Access Compliance Report

Public Rights-of-Way

(Pedestrian Signals)

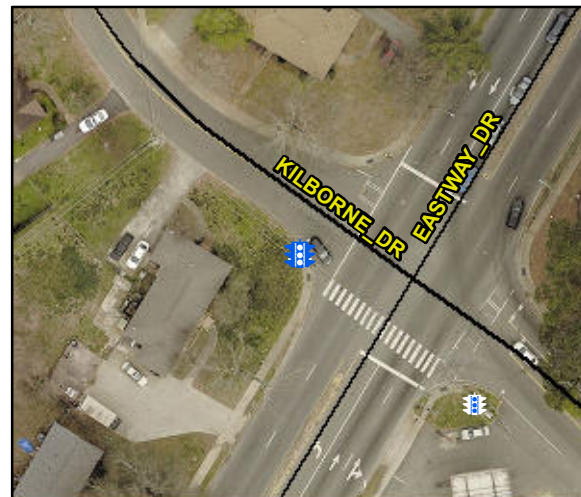
No	B 1 Clear Xing Direction?	NotClearlyMarked	N/A	B 2 Clear Xing Direction?	N/A
	B 1 Crossing Direction	To NE		B 2 Crossing Direction	N/A
No	B 1 DistanceTo XWalk (in)	73.0	N/A	B 2 DistanceTo XWalk (in)	N/A
No	B 1 DistanceTo Curb (in)	14.0	N/A	B 2 DistanceTo Curb (in)	N/A
Yes	B 1 Diameter (in)	2.0	N/A	B 2 Diameter (in)	N/A

Possible Solutions: Replace Signal Push Button With APS Button on New Post. Remove & Replace Sign.

PROW/ADA: TMUTCD 4e.08, R209.1, R410.6, R404.2, R404.3
